Worcester Township Planning Commission

Re: MCPC #25-0009-001
Plan Name: 2991 Mohill Road Minor Subdivision
(2 lots, approximately 3.42 acres)
Situate: 2991 Mohill Road, near Valley Forge Road
Worcester Township

Reference: 2991 Mohill Road
Parcel No. 67-00-02449-00-4
Minor Subdivision Plan Review
Worcester Twp. LD

RE: **Traffic Review #1 – Minor Subdivision Plan**
2991 Mohill Drive – Two single family lots
Worcester Township, Montgomery County, PA
Project No. 313982-25-002

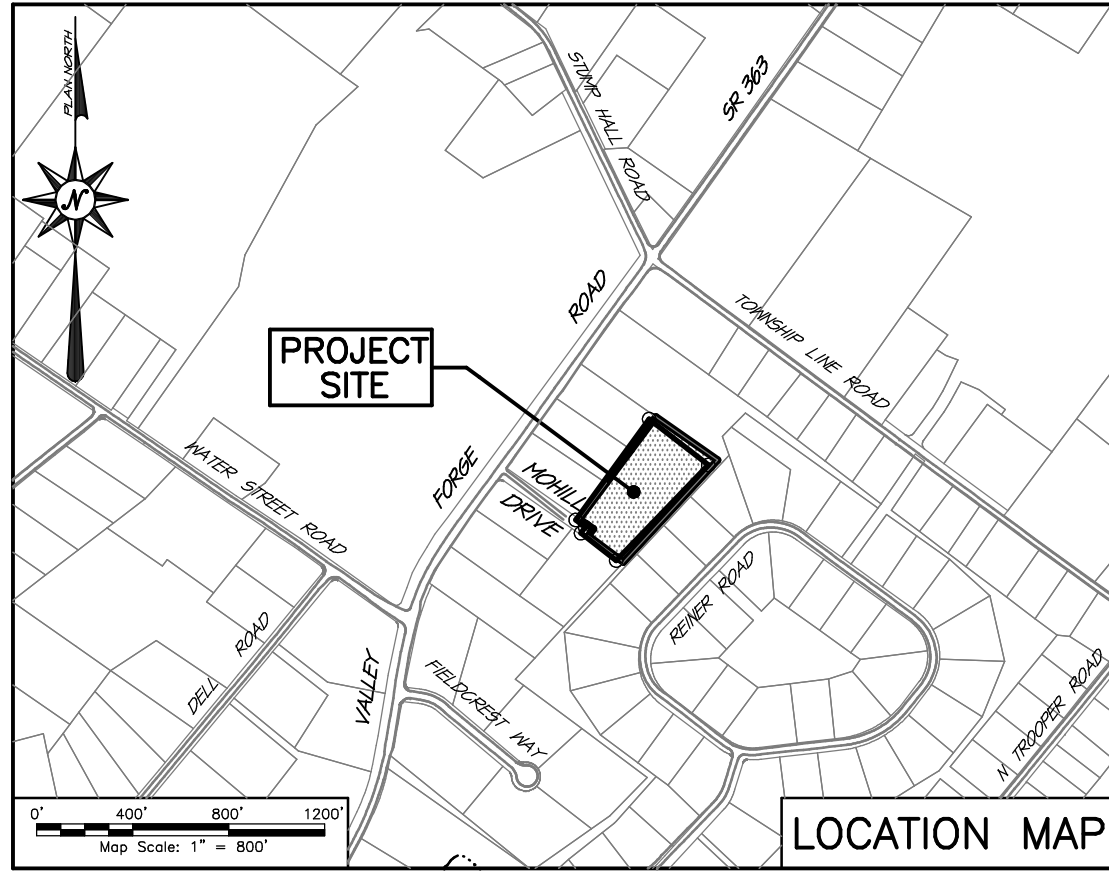
The plan shows an existing septic tank on Proposed Lot 1 and septic beds on Proposed Lot 1 and Proposed Lot 2. Percolation test results for these proposed systems were not included in the submission. The plan notes that the soil where the systems are proposed is Readington silt loam, which the USDA Web Based Soil Survey describes as moderately well drained, with moderate limitations for on-lot systems. The applicant or the Township should provide guidance to the property owners on inspection and maintenance requirements for these systems to ensure their continued effective operation.

1. The proposed use of Lot 2, single-family detached dwelling, is permitted by-right in the R-175 District if development is in accordance with the regulations of the R-175 District.
2. As per the definition of "front yard", the front yard on Lot 2 should be from the southwesterly lot line. (150-9)

1. Note 10 indicates that public water to this property is provided by PA American Water Company; however, no existing water mains are shown on the plan and an existing well has been shown on Proposed Lot 1. In accordance with Section 130-14.F, if no public water supply is available for the proposed subdivision, the Supervisors shall require the developer or builder to obtain from the Montgomery County Department of Health certificates of approval as to the quality and adequacy of the water supply to be utilized and approval of the type and construction methods to be employed in the installation of the individual water supply system.

2. Septic beds are shown on both Lots 1 and 2. In accordance with Section 130-14.G, the Supervisors shall require the subdivider, developer, or builder to obtain from the Montgomery County Department of Health certificates of approval of the sewage disposal facilities to be provided.

No portion of an on-site sewage disposal system shall be within the area between 10 feet and 30 feet of any property line. It appears that the useable area shown for the septic bed on Lot 1 is less than 30 feet from the southerly property line. (Section 130-26.B.2.c)

In addition, no disseminating system shall be located uphill from a drilled well and not closer than 100 feet to it. (Section 130-26.B.2d)

3. Applicants shall observe the ultimate rights-of-way for continuous existing streets. The ultimate right-of-way for Mohill Drive is 50 feet as per Chapter 126. The plan shows the right-of-way to be 40 feet and therefore, an additional 5 feet (1/2 width) should be shown across the lot frontages and this additional right-of-way offered to the Township. Applicable building setback lines shall be delineated as measured from the ultimate right-of-way street line. (Section 130-14.H).

4. The minimum paved width of Mohill Road should be 28 feet. The plans indicate a 17-foot-wide cartway. (Section 130-16.C.1.a.4) Alternatively, the existing Mohill Road serves three existing parcels. Section 130-17.C(2) notes that driveways used as private streets must be a minimum of 20 feet. It is our understanding that the Township does not maintain Mohill Road and it is not eligible for liquid fuels.

5. Concrete curb and sidewalk should be constructed along residential streets. We note there is no curbing or sidewalks in the vicinity of the existing driveway. (Sections 130-18.A and B)

8. Lots 1 and 2 must provide a softening buffer along its side and rear lot lines. The buffer shall consist of a minimum of one evergreen tree for each 35 linear feet; one ornamental or shade tree for each 50 linear feet; and one shrub for each 10 linear feet of property line. Informal groupings of more closely spaced plants which reflect the natural character of the site are encouraged. Existing vegetation of appropriate species and quantities on the property can be considered in the fulfillment of these requirements. The plan does not propose any buffer plantings. (130-28.G.5.b)

9. A minimum of three deciduous or evergreen trees must be proposed to be planted on Lot 2, unless an equivalent number of existing trees are already on the lot. (130-28.9.A)
10. The future well on proposed Lot 2 must be constructed in accordance with PADEP and Township requirements. (130-31.C)
11. Areas of steep slopes on the lot must be defined. If none are present, this condition should be stated as a general plan note. (130-32.1)

5. A copy of the deed should be submitted.
6. The revision date on the plan should be corrected to 01/02/25.
7. It should be determined if any of the Development Notes shown on the plan are applicable to this subdivision.

8. Lot 1 and Block 6, Unit 34 share an existing driveway. The existing driveway easement must be shown or a new easement proposed.
9. The applicant is made aware that any improvements to Lot 2 that result in an increase of more than 1,200 s.f. of impervious area will require stormwater management.

2. Since access to the proposed two-lot subdivision is ultimately provided through the intersection of Valley Forge Road (S.R. 0363) and Mohill Drive, vehicle sight distances must be provided on the plan for a vehicle exiting Mohill Drive and looking in both directions at 14.5 feet back from the edge of the closest travel lane on Valley Forge Road (S.R. 0363), as well as the sight distance looking ahead and to the rear for a vehicle making a left-turn from Valley Forge Road (S.R. 0363) onto Mohill Drive. It appears that the egressing sight distance looking to the left may be restricted due to a dense line of vegetation. The sight distances must be confirmed and if the clear and minimum

3. According to **Section 130-16.C(1)(a)[4]** of the **Subdivision and Land Development Ordinance**, Mohill Drive should have an ultimate right-of-way width of 50 feet. The plan currently shows a 40-foot ultimate right-of-way width along the Mohill Drive site frontage, thereby not satisfying the ordinance requirement. The plan should be revised to show a 50-foot ultimate right-of-way width along the Mohill Drive site frontage, or a waiver needs to be requested from this ordinance requirement and approved by the Board of Supervisors.

4. According to **Section 130-16.C(1)(a)[4]** of the **Subdivision and Land Development Ordinance**, Mohill Drive should have a cartway width of 32 feet, which may be reduced to as low as 28 feet when conditions may be unreasonable for this widening. The plan currently shows an approximate 18-foot cartway width along the Mohill Drive site frontage, thereby not satisfying the ordinance requirement. The plan should be revised to show a at least a 28-foot cartway width along the Mohill Drive site frontage, or a waiver needs to be requested from this ordinance requirement and approved by the Board of Supervisors.

7. According to **Section 130-18.A** of the **Subdivision and Land Development Ordinance**, sidewalk should be provided along the site frontage of Mohill Drive. The plan currently does not show any sidewalk along the Mohill Drive site frontage, thereby not satisfying the ordinance requirement. The plan should be revised to show sidewalk along the Mohill Drive site frontage, or a waiver needs to be requested from this ordinance requirement and approved by the Board of Supervisors. The Board of Supervisors may decide to consider deferring this sidewalk obligation that is required of the applicant until such a time as may be required by the Township along the subject property,

8. According to **Section 130-18.B** of the **Subdivision and Land Development Ordinance**, curbing should be provided along the site frontage of Mohill Drive. The plan currently does not show any curbing along the Mohill Drive site frontage, thereby not satisfying the ordinance requirement. The plan should be revised to show curbing along the Mohill Drive site frontage, or a waiver needs to be requested from this ordinance requirement and approved by the Board of Supervisors. The Board of Supervisors may decide to consider deferring this curbing obligation that is required of the applicant until such a time as may be required by the Township along the subject property, whether under present or future land ownership, and at no cost to Worcester Township. However, if the Board of Supervisors grants this waiver, we recommend to them and the Township Solicitor that the applicant then provide a contribution in an escrow to the Township in an amount similar to the cost to install said improvements to be used for similar improvements in the vicinity of the site or within the Township.
